Service Bulletin

SUBJECT: Service Update for Inventory and Customer Vehicles
Body Harness Contact with Park Brake Bracket
Expires with Base Warranty

MODELS: 2014-2015 Chevrolet Silverado
2014-2015 GMC Sierra

The Service Procedure section has been revised. Please discard all copies of bulletin 14725

4109183

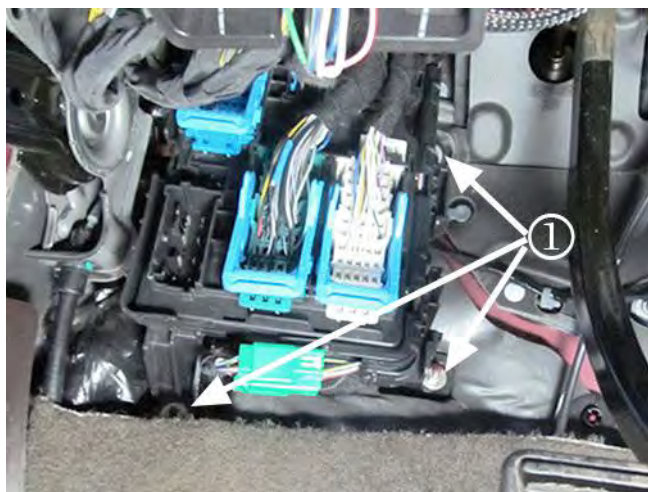
5. Locate the branch-out harness and reposition towards the body harness. A tie strap will be added around both harnesses to increase clearance to the park brake bracket.

6. Locally obtain a tie strap to secure the branch-out to the body harness. To assist installation, it may be helpful to kink the tie strap as shown in the graphic above.

7. Secure the branch harness away from the park brake bracket by adding the tie strap at the approximate location shown in the graphic above. Verify increased clearance between the harness and the park brake bracket.
8. Reconnect the park brake switch terminal (1) and attach the harness retainer (2) from the body stud.
